SDE Upgrade

WP5 ECRs

WP5 Proposal

ECR 15.12, Change Power supply connector position:

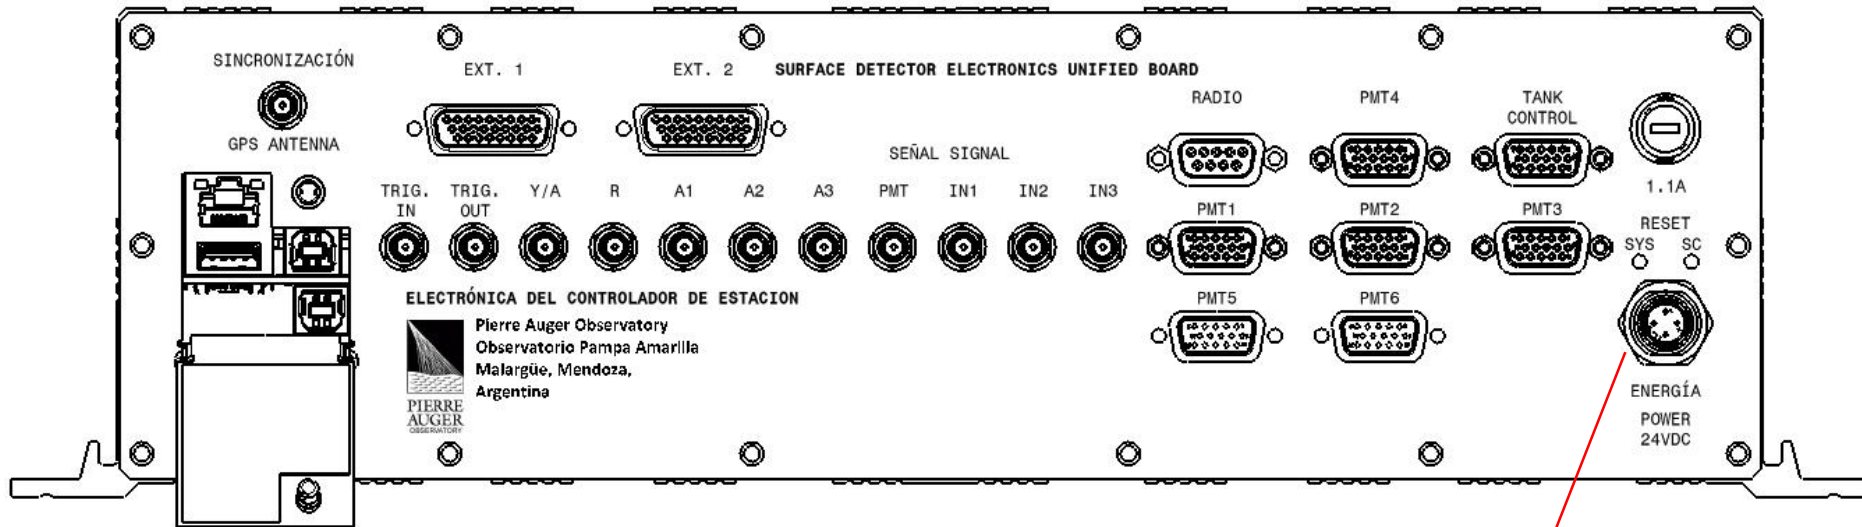
Away from Front-end area on PCB to lower the noise (actual position -> specification request).

ECR 15.13, Move Slow-control layout block:

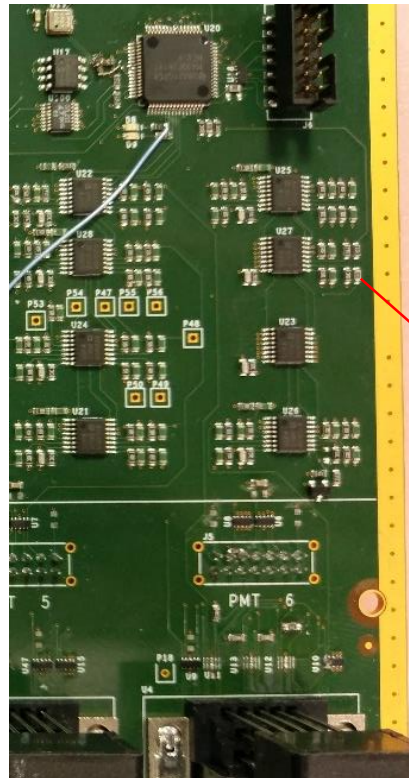
Slow-control block must be moved to the left. Resistor could be in short-cut if they are too close the box.

Passive component could
be in contact with box

ECR 15.16, Fuse wires connection to board:

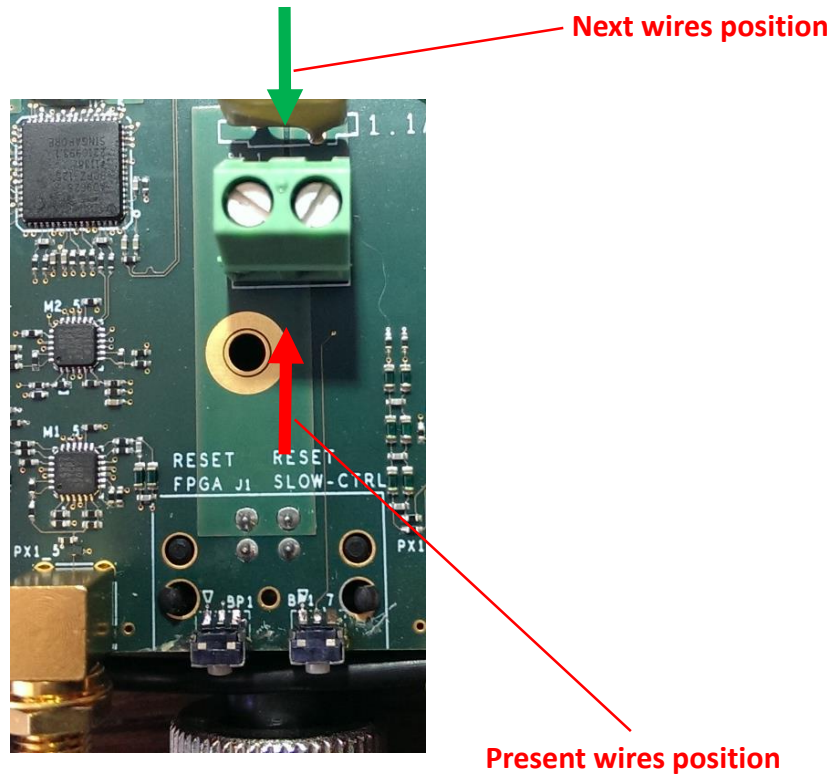
Reverse screw connector for fuse wires (NCR n° 2-58).

ECR 5.11, Move or remove holes on PCB:

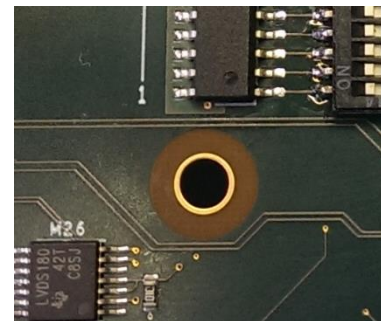
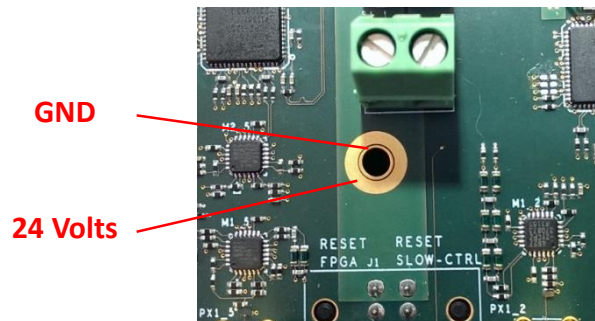
Holes was put on PCB in compliance with the UB. They are used only for debugging. Not used in SDE box.

ECR 15.22, Ethernet PoE integration:

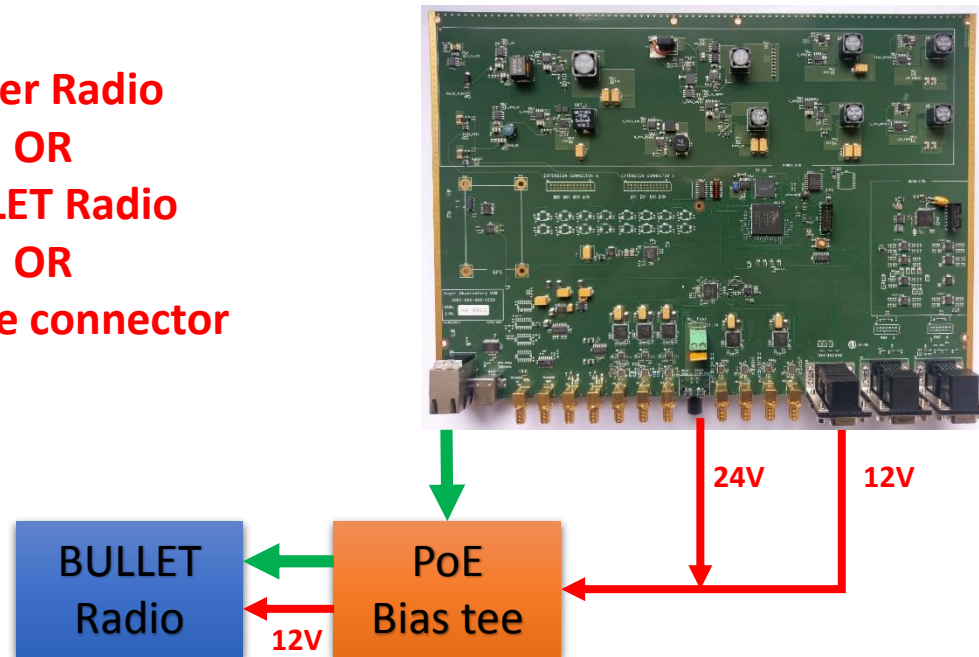
Combo connector Eth + USB with PoE: does not exist

No other solution than bias Tee

Auger Radio
OR
BULLET Radio
OR
Remove connector

ECR 15.24, Start problem Slow-control micro-controller:

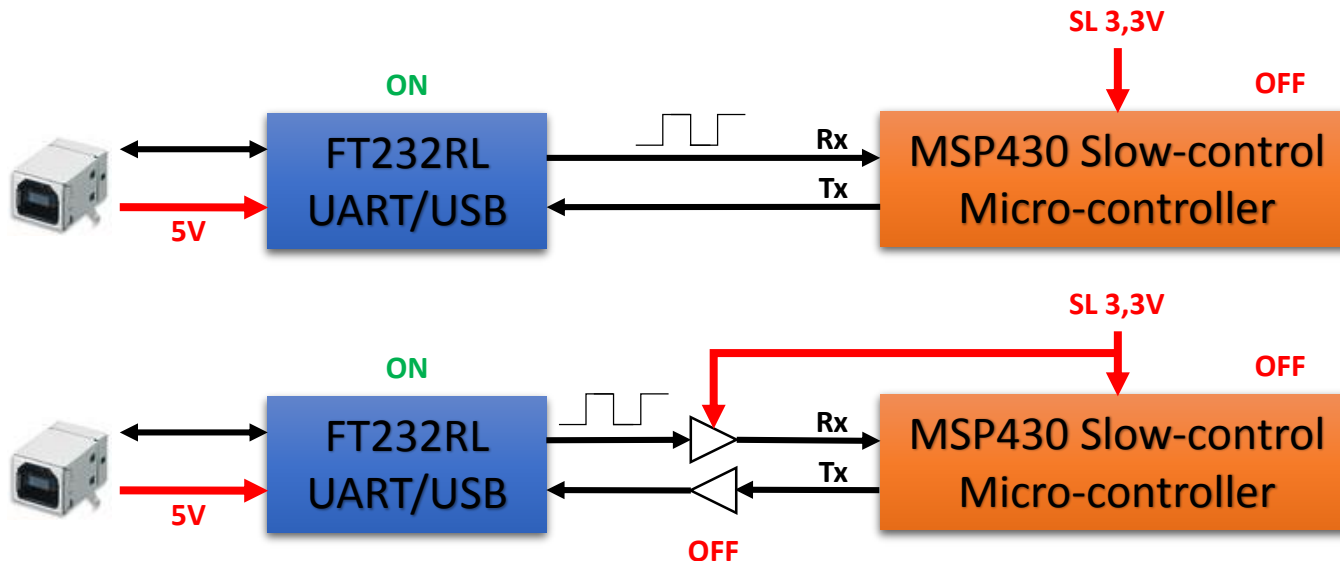
Sometime, the micro-control stopes during start sequence (NCR n° 2-67). Only when a PC is connected before the UUB turn ON.

This must be made also for FPGA UART.

- **ECR 15.26, Front-panel window:**

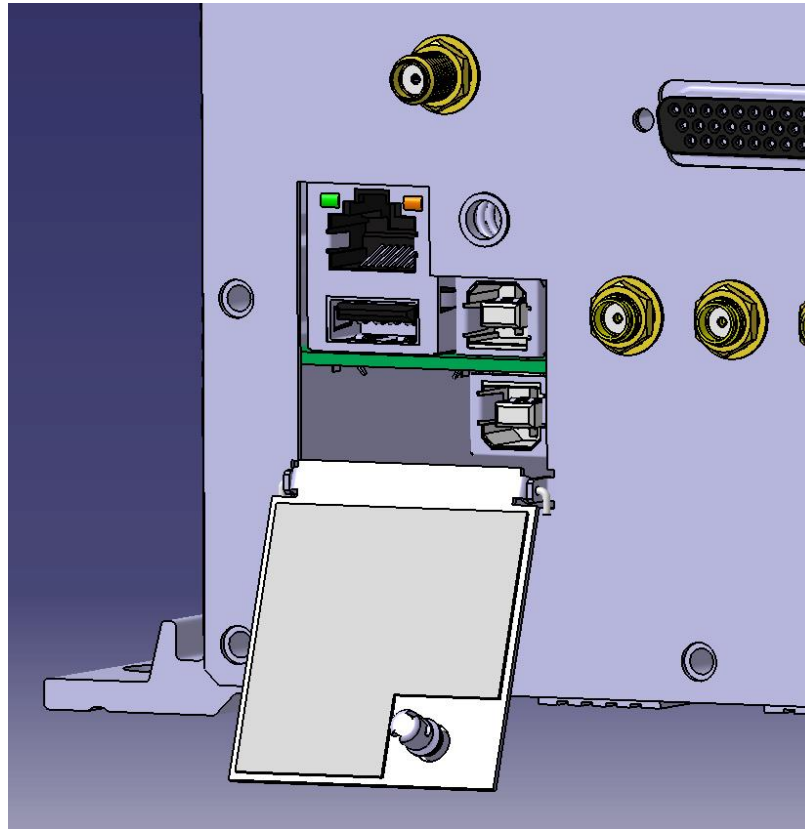
The Front-panel window is still not defined or confirmed. Presently only the WP5 proposal is available.

ECR 15.29, Solar power system Slow-control management:

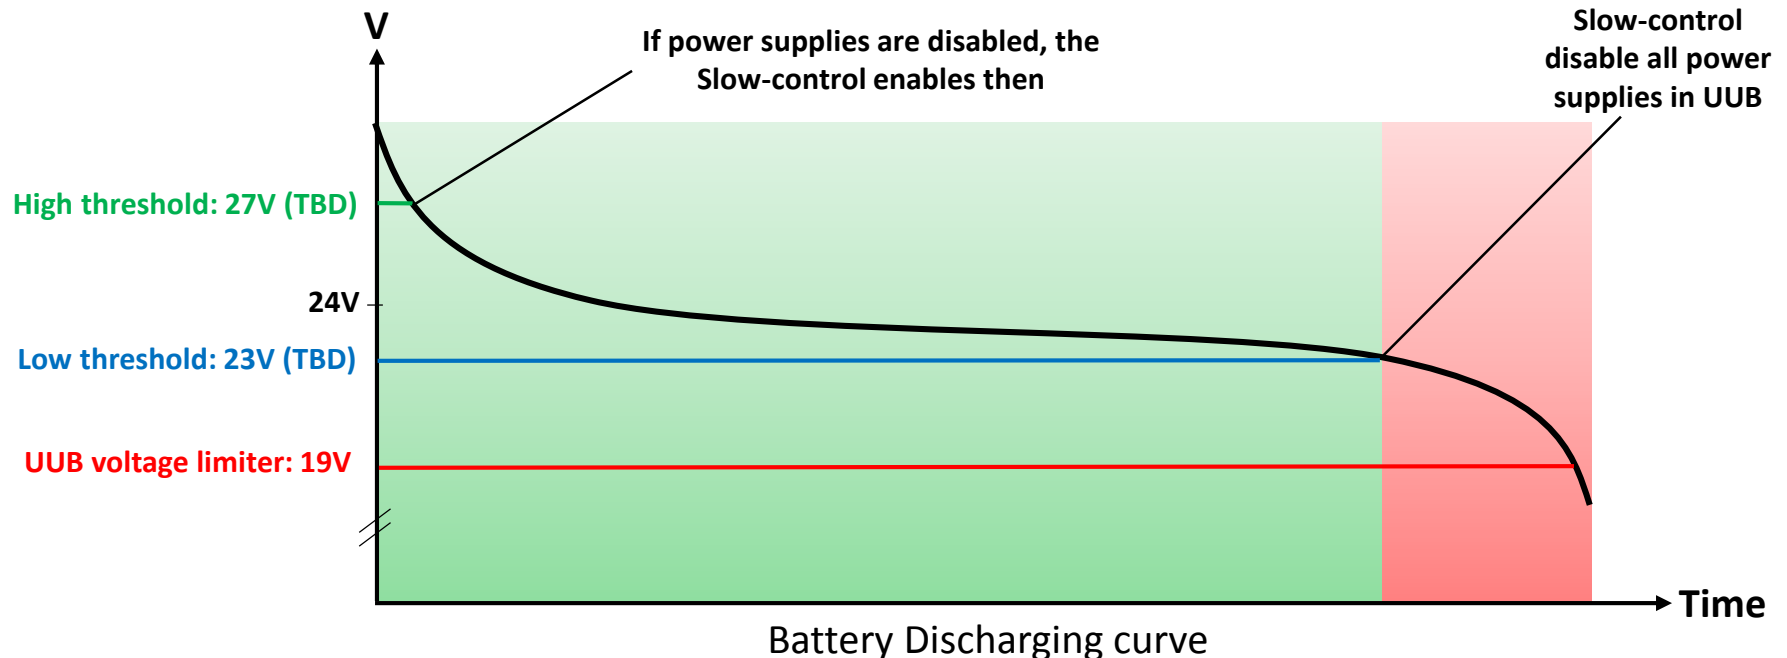
If the battery voltage is too low, the electronic will twinkle. Could damage electronic and battery.

No hardware modification, only Slow-control software.
